Appendix G:
Wastewater Facilities Review for Cordoba Center
Project

***Wastewater Facilities Review
For
Cordoba Center Project
Santa Clara County, California***

Project #1700037

***Prepared By
Questa Engineering Corporation
1220 Brickyard Cove Road, Suite 206
Richmond, California 94807***

FIGURE
2

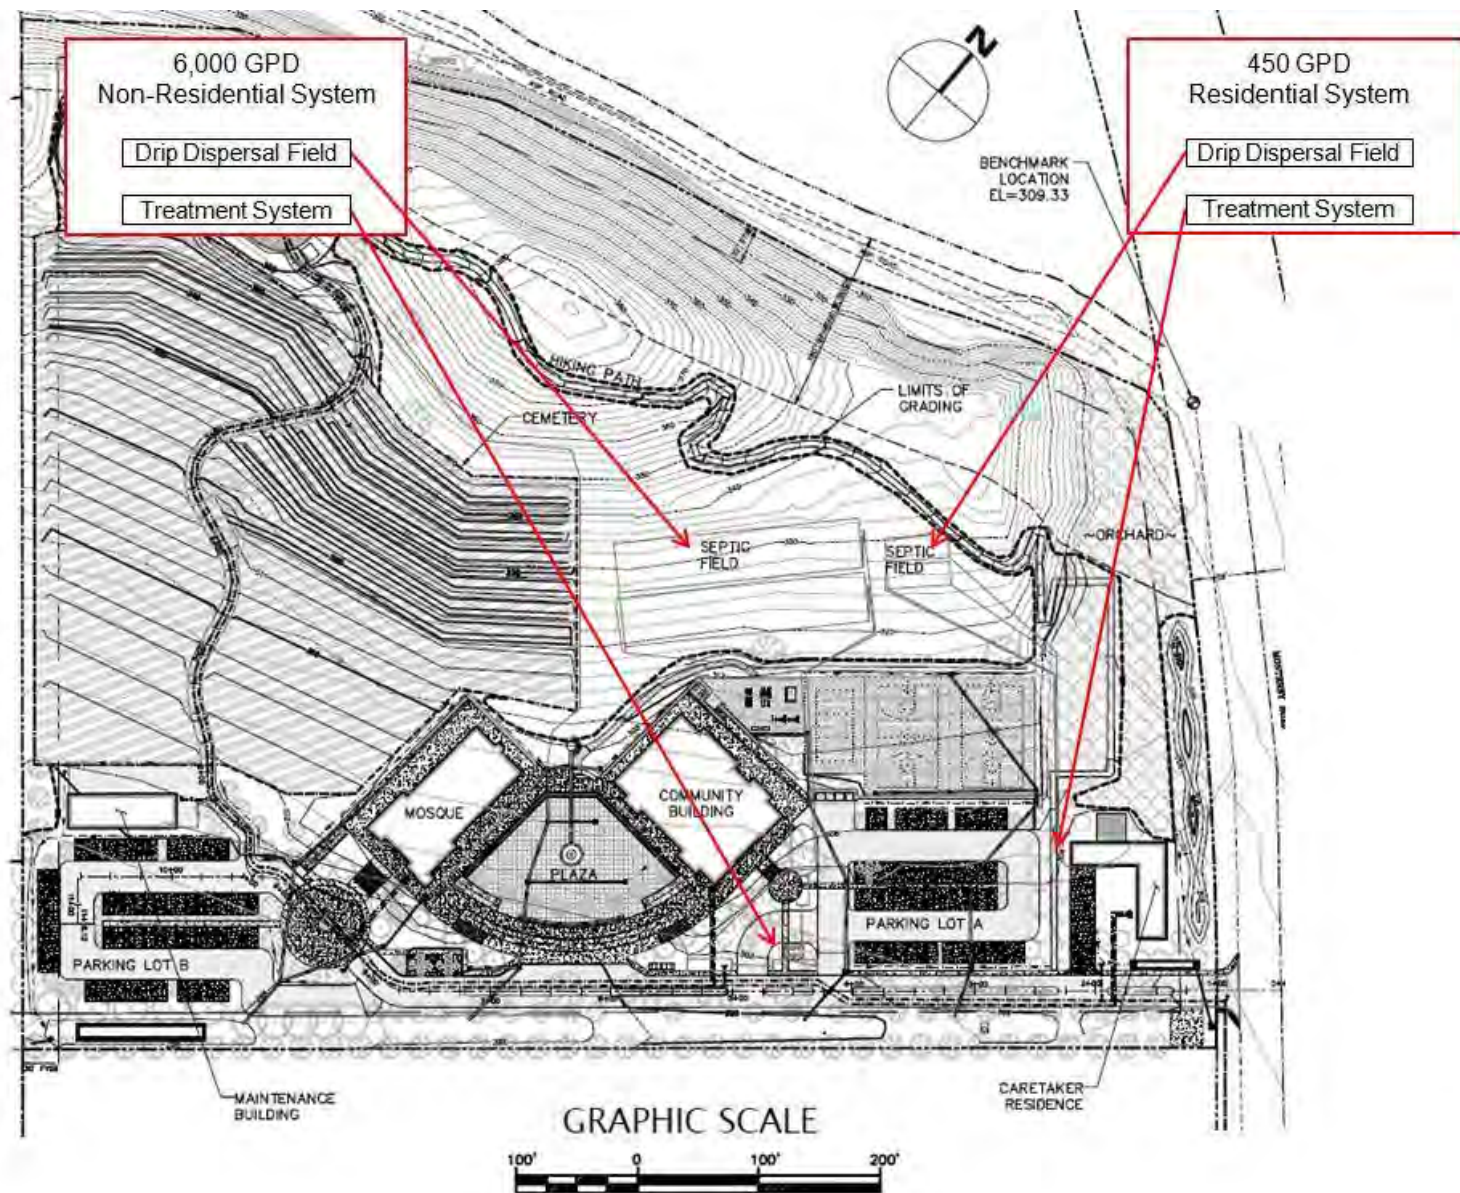
Both systems would utilize septic tanks followed by supplemental/secondary treatment units (Multi-Flo™), followed by disposal to separate subsurface drip dispersal fields located near the center of the property, on the hillside immediately north and upslope of the community building and sports-courts/playground area (**Figure 2**).

FIGURE
 6

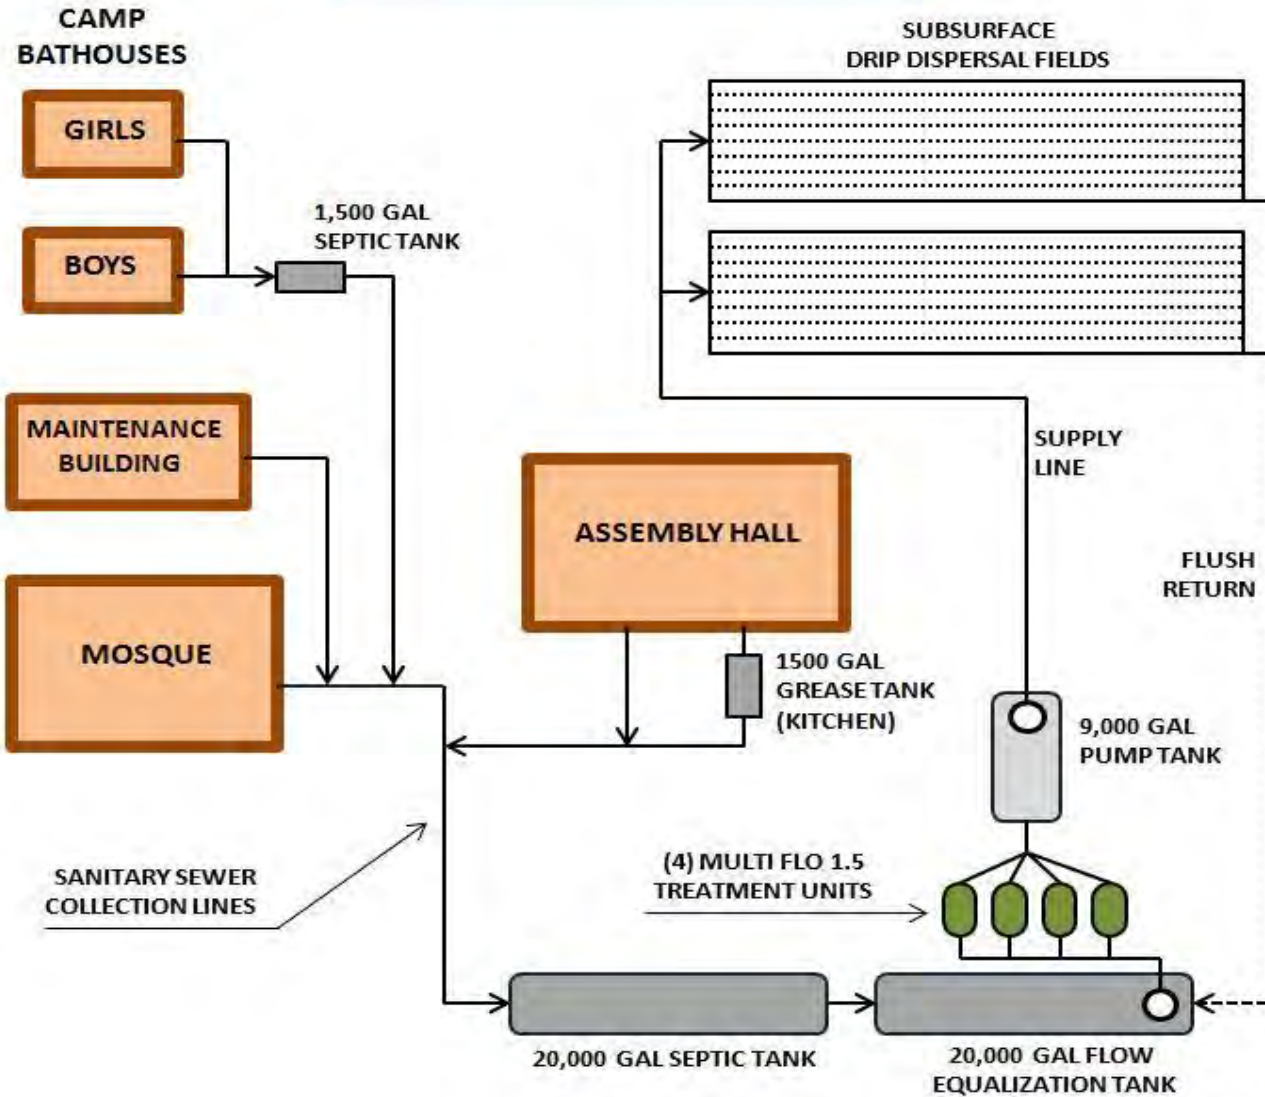
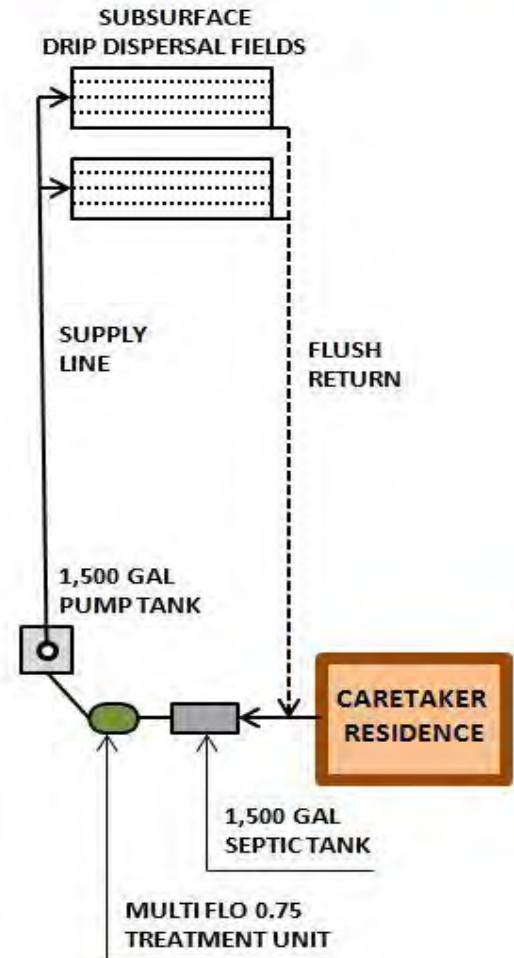
The supplemental/secondary treatment systems proposed for both the Caretaker residence and the non-residential systems are required, at a minimum, for any system utilizing drip dispersal methods. The particular system proposed, Multi-Flo, has proper NSF 40 certification (as required by the *Onsite Systems Manual*) for production of secondary quality wastewater effluent.

The Multi-Flo system has good reported performance in meeting secondary treatment standards. However, it does not have design features or demonstrated capability for significant nitrogen removal (Multi-Flo Design Manual, 2003). As addressed below under Cumulative Impacts Analysis, the wastewater treatment system will need to incorporate nitrogen removal features in order to meet a minimum effluent nitrogen limit (average monthly concentration) of 20 mg-N/L or less. Treatment system options are available that can achieve nitrogen removal to this levels; however, the Multi-Flo system as proposed is not among the options. Consequently, the proposed wastewater facilities plan will have to be modified to include a supplemental treatment system capable of meeting a 20 mg/L (average) nitrogen effluent performance limit as well as meeting basic NSF 40 secondary treatment requirements. Wastewater effluent monitoring requirements should be established by the DEH as conditions of the operating permit for the project to provide on-going assurance that the system performs as required.

FIGURE
8

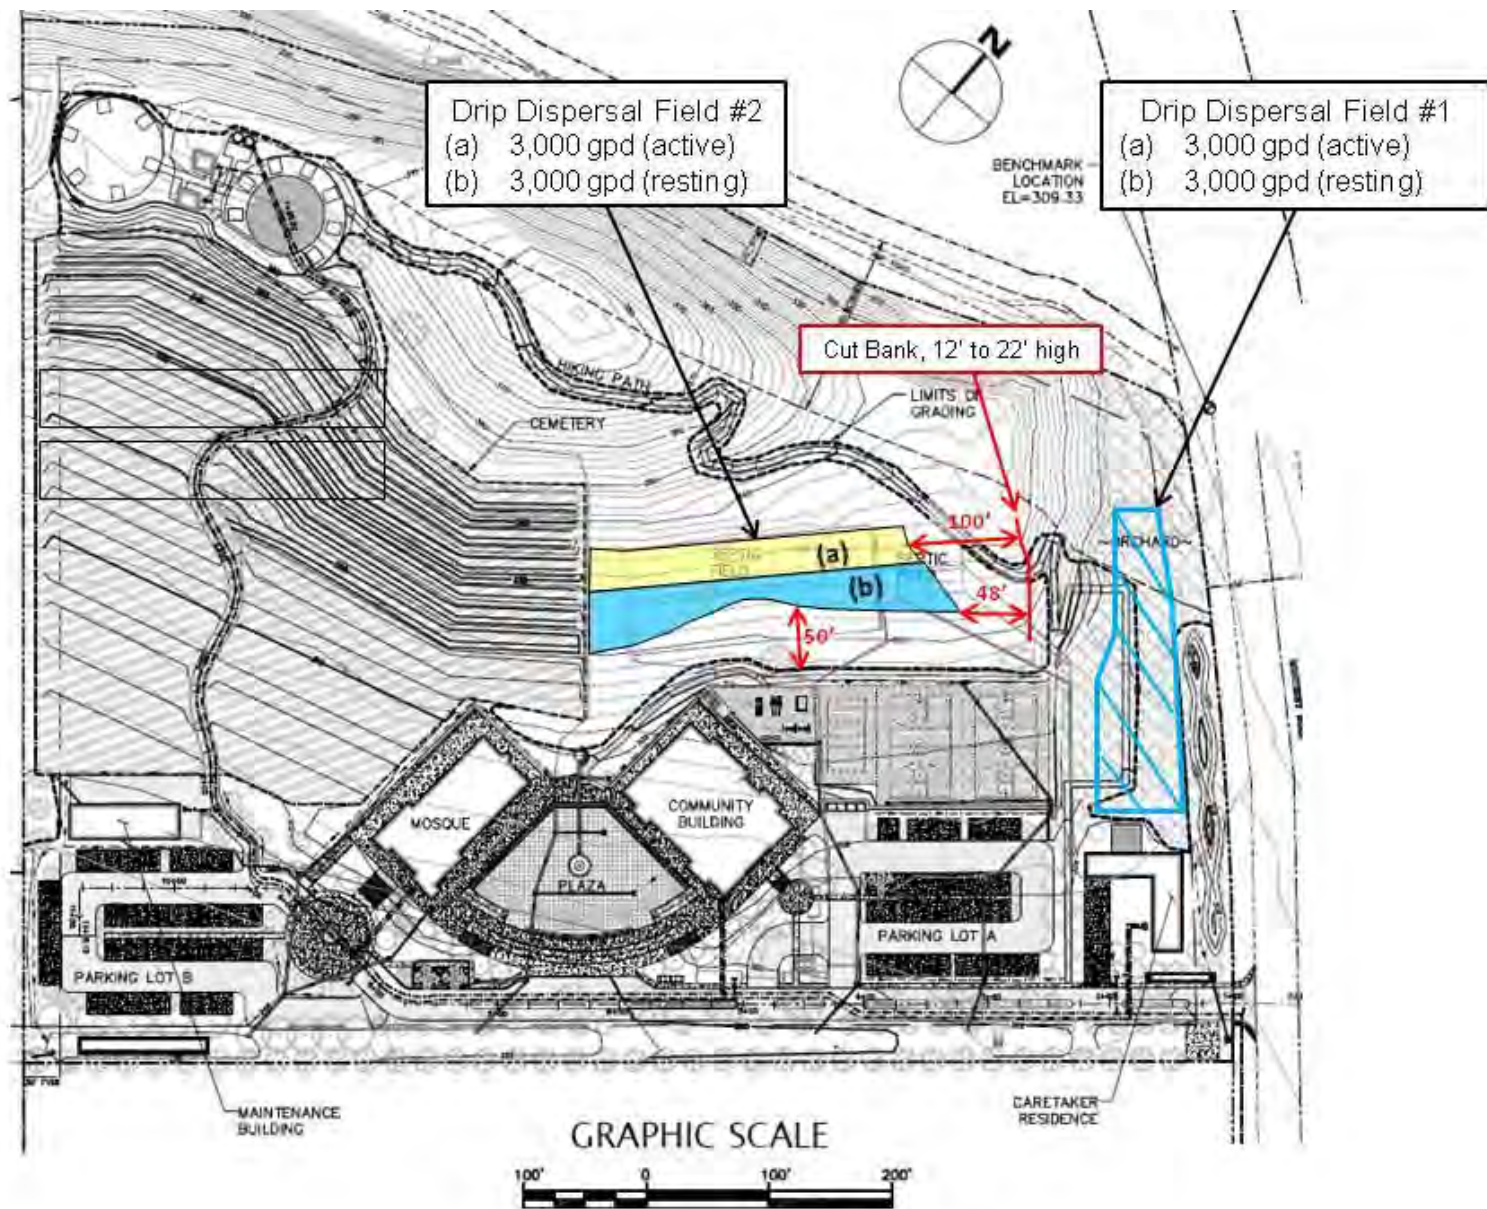
Cut Slope Setback. Per County regulations, the required horizontal setback distance between a dispersal field and cut slope or embankment is equal to four (4) times the height (h) of the cut slope (i.e., “4xh”) measured from the top of the slope. The proposed wastewater plans are in conflict with this requirement as follows:

- **Residential System.** About half of the proposed residential wastewater dispersal field is situated within the required horizontal setback distance to the exiting cut slope located to the east, toward Monterey Road. Based on the varied height of the cut, the required setback distance (4xh) would be about 60 to 100 feet. As diagrammed in the applicant’s septic system plan, the proposed dispersal field maintains a setback of about 50 to 60 feet from the cut slope. Therefore, reconfiguration of the residential wastewater dispersal field is required to comply with County requirements. There appears to be sufficient available area to allow this adjustment to be made.

- **Non-residential System.** The horizontal distance between the non-residential dispersal field and the proposed cut slope adjacent to the pathway along the north side of the play area and sports courts does not meet the necessary setback requirements. As illustrated in **Figure 7**, with the expected development of perched lateral groundwater flow conditions beneath the proposed drip dispersal field, there is a strong likelihood of downslope seepage (“breakout”) of wastewater effluent at the proposed cut slope above the playground and recreation area. County requirements for setbacks to cut slopes specify a minimum distance of 25 feet and four (4) times the height (h) of the cut, whichever is greater. The *Onsite Systems Manual* also includes requirements and guidelines for geotechnical assessment of wastewater disposal systems that call-out the need to assess and establish appropriate setbacks from cut slopes based on site specific soils, geology and drainage conditions. Based on observed soil conditions (stiff sandy clay at 4-ft depth), the potential for creation of lateral perched groundwater flow conditions, and proposed grading plans, in our opinion a minimum horizontal setback distance of 50 feet should be maintained between the non-residential drip dispersal fields and the proposed cut slope in question. A 50-foot setback would be equivalent to the required setback from a drainage ditch.

Mitigated Wastewater Disposal Plan. Compliance with the above recommendations for reduced hydraulic loading in the proposed dripfield area and increased horizontal setback to the cut slopes can be accomplished by: (a) eliminating the lower non-residential drip dispersal field shown on the proposed project wastewater plan; (b) reconfiguring the area for the residential drip dispersal field to maintain 60 to 100-ft setback from the easterly cut slope (see **Figure 8**); (c) confining drip dispersal to the area higher up on the hillside in areas of less than 20% slope and within the area already percolation-tested; (d) extending the non-residential drip field a greater distance laterally across the slope (250 to 300 feet); and (e) developing an additional alternate drip dispersal field in the orchard area on the east side of property with capacity for 50 percent of the design wastewater flow.

The above mitigated plan is illustrated in **Figure 8**. Under this mitigated approach, the hillside drip field and the recommended orchard drip field would be operated in tandem, each receiving 50% of the daily wastewater flow. Individually, each field would have a primary (active) and secondary (resting) drip dispersal system installed to meet minimum requirements for a dual, 200% capacity dispersal system. Combining the flow from the Caretaker's residence into the non-residential system to have a single system is recommended for operational efficiency, but would not be essential. Drip field design for the hillside area should be based on an application rate of 0.4 gpd/ft², applicable to soils with percolation rates averaging 46 to 60 MPI, which has been demonstrated for this area. For a design flow of 3,000 gpd (50% of total flow) this would require two fields of 7,500 ft² each. The two hillside drip dispersal fields ("a" and "b") diagrammed in **Figure 8** have areas of about 9,000 ft² and 10,000 ft², respectively.
